**Board of Architectural Review**

DATE: July 17, 2015  
TO: Board of Architectural Review Chair and Members  
THROUGH: Jason Sutphin, Community Development Division Chief *JDS*  
FROM: Kelly O'Brien, AICP, BAR Liaison *KO*  
SUBJECT: **Advance Auto Parts– 9738 Fairfax Boulevard**

| 3. Request:                    | Renovation of one-story restaurant into retail store                        |

EXTERIOR  
ELEVATIONS

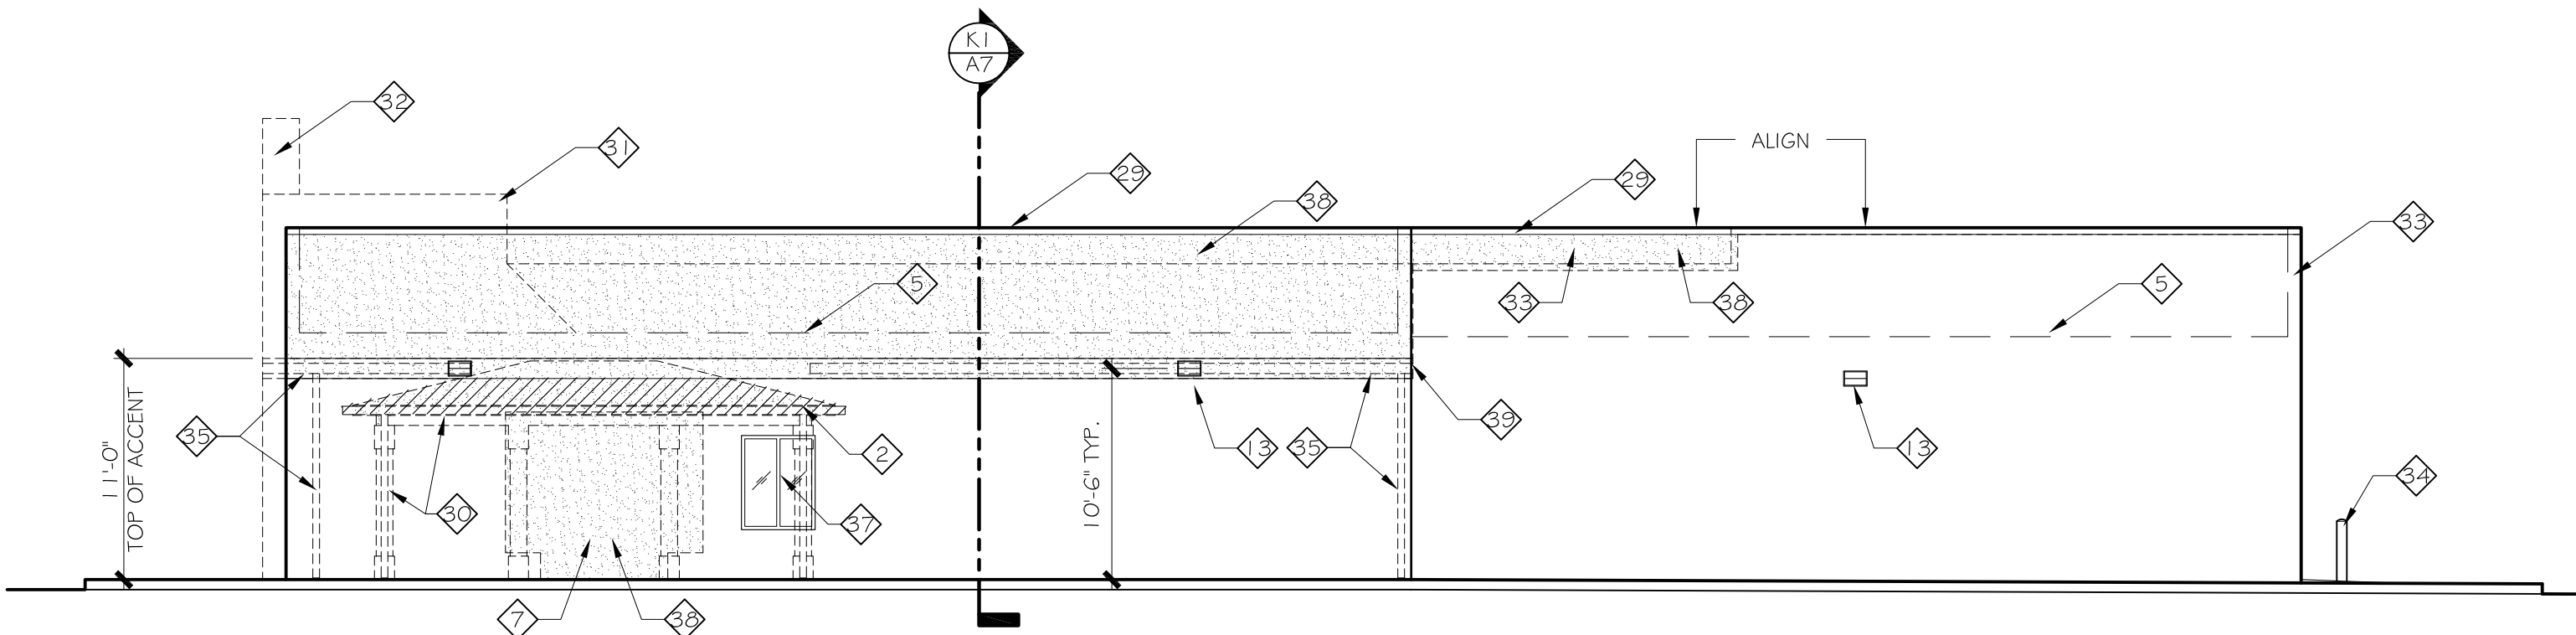
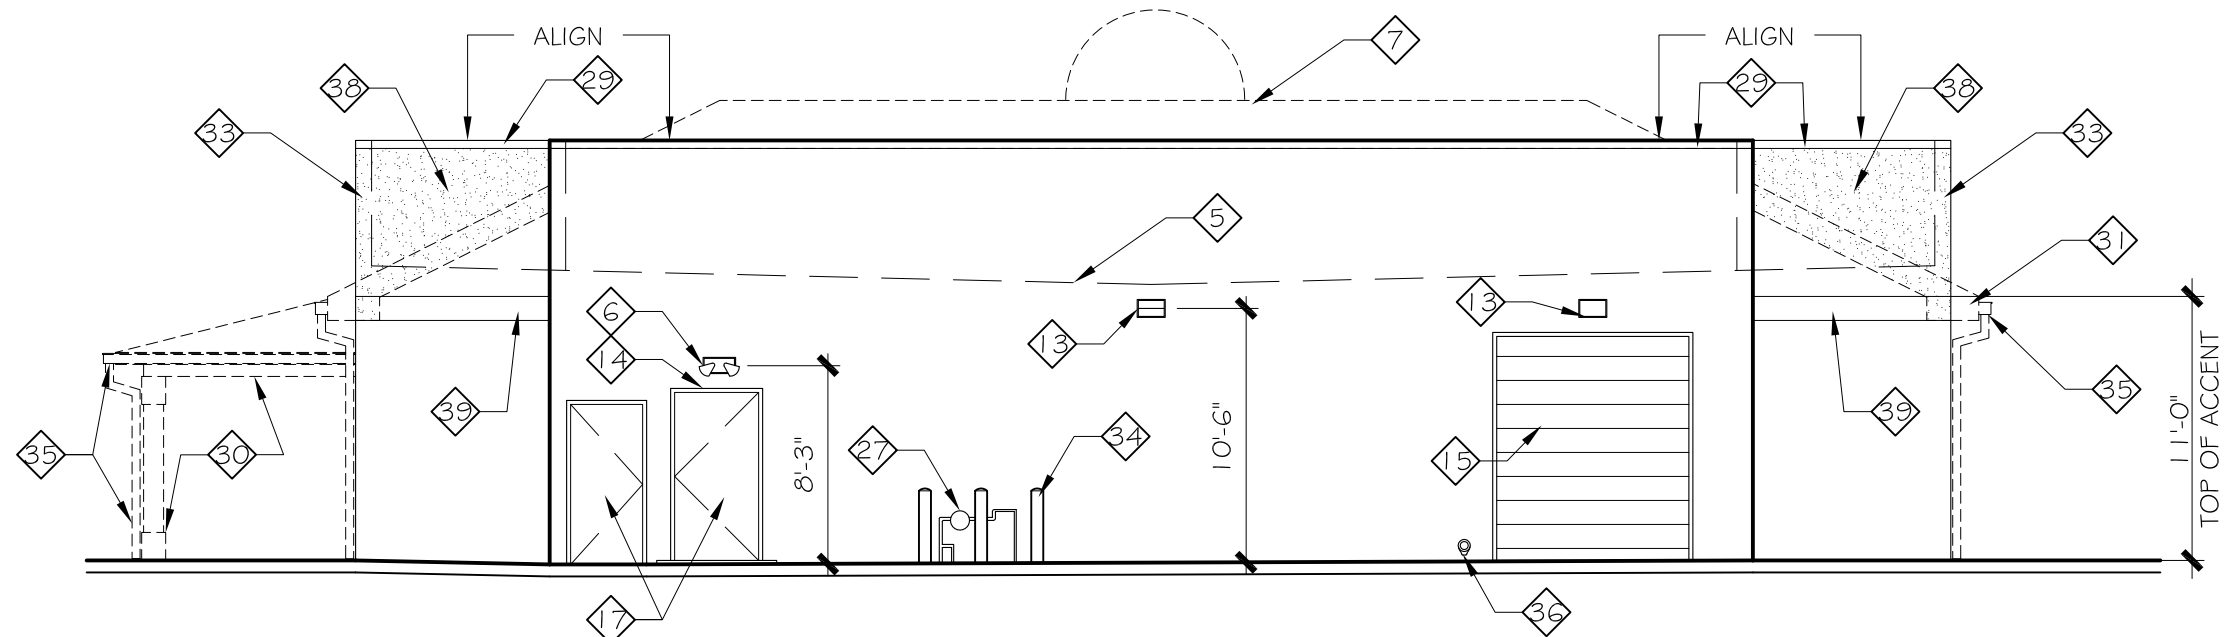
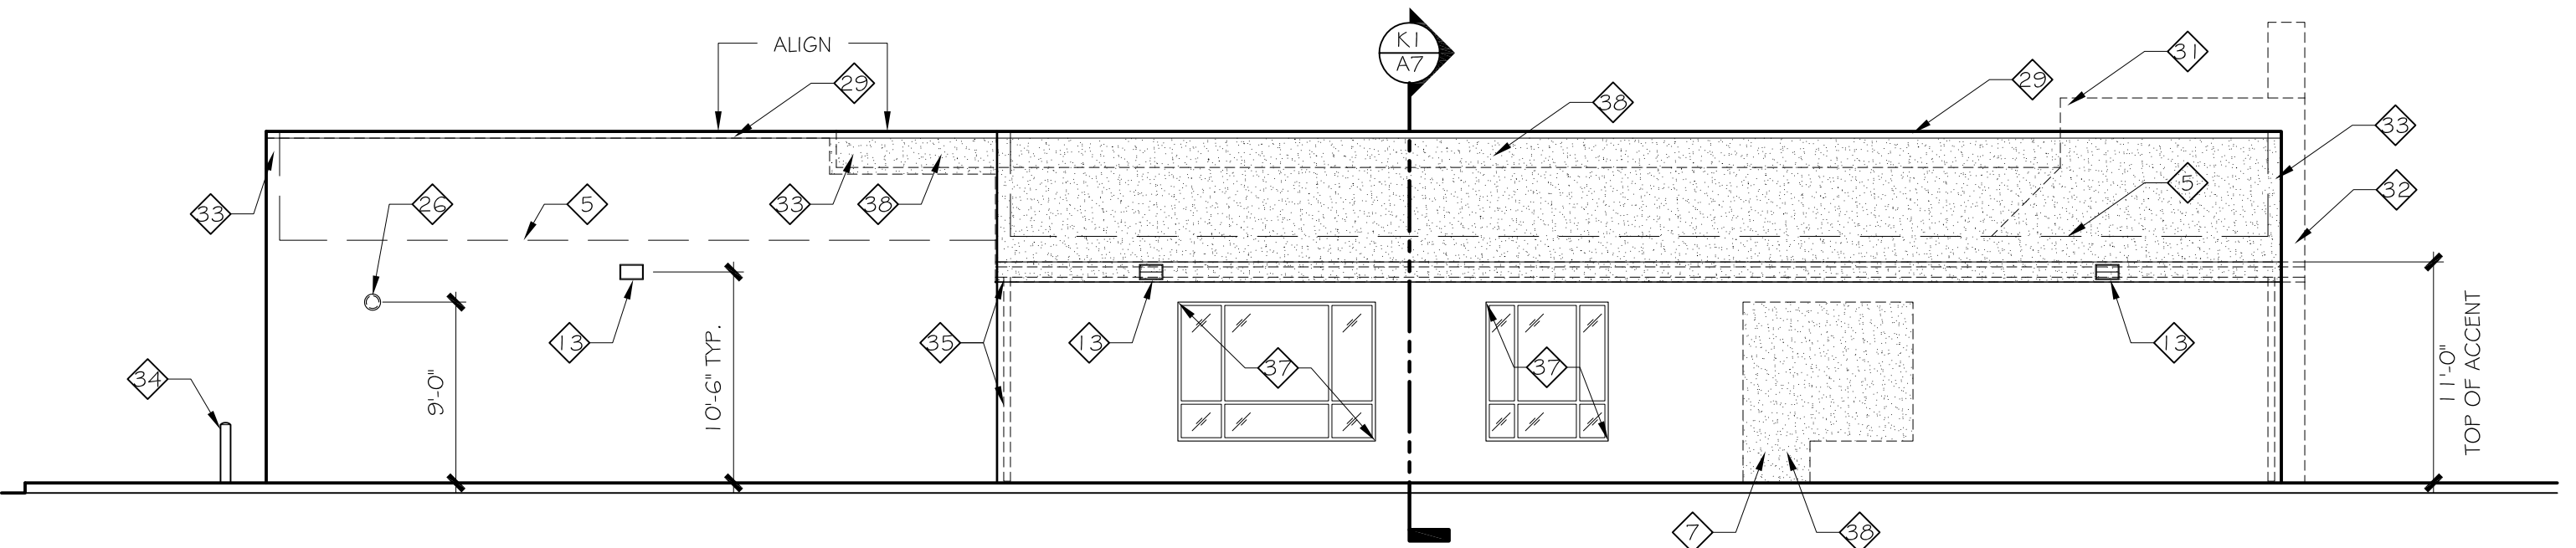
A new storefront entrance with mill finish aluminum frames and clear glass is proposed to replace the arches and columns on the existing front façade. The windows on either side of the entrance will remain, however, they interior of the glass is proposed to have black film applied to screen the shelving system of the store displays against the windows. Red fabric awnings are proposed over the existing windows per staff's request.

On the east elevation of the building facing the parking lot, the double door storefront will be removed and infilled with EIFS. A window similar to the window that exists to the right of this area will be installed in place of the doors. All windows are proposed with black glazing on the interior.

On the west elevation facing Draper Drive, the existing windows will remain. The existing storefront with a wood door with glass panel was originally proposed to be removed and infilled, however, staff requested that it remain. The applicant proposes to paint the frames of the window black to match the others and paint the door 'Quest Grey' to match the walls, seal the door shut and remove the hardware as it will not be used as an egress. Staff's recommendation was to replace the wood door with a black metal frame with glass panel door to match the window frames. The applicant stated the condition of the existing storefront would make it very difficult and costly to fit a new door.

*While it is a moderate improvement to existing conditions, staff would like to have seen better quality materials and design elements as was used on adjacent properties and is recommended in the Community Appearance Plan, which places a preference on quality materials and a design that works with surrounding architecture. In general, staff is in support of the proposed design as an improvement to existing conditions and appreciates the applicant's willingness to compromise on some design elements requested by staff.*

1. The proposed construction, materials, and colors shall conform to the elevations and material samples provided by the Applicant, and as may be modified below or as may be modified to reflect any additional improvements that may be required by the Zoning Ordinance, Building Code and/or the Board of Architectural Review, and as may be modified by the Director of Community Development and Planning.
2. The applicant shall secure all required building and sign permits prior to installation of signs.
3. The applicant shall install hedgerows and three deciduous trees as identified in the staff report and on the marked up approved landscape plan per City standards.
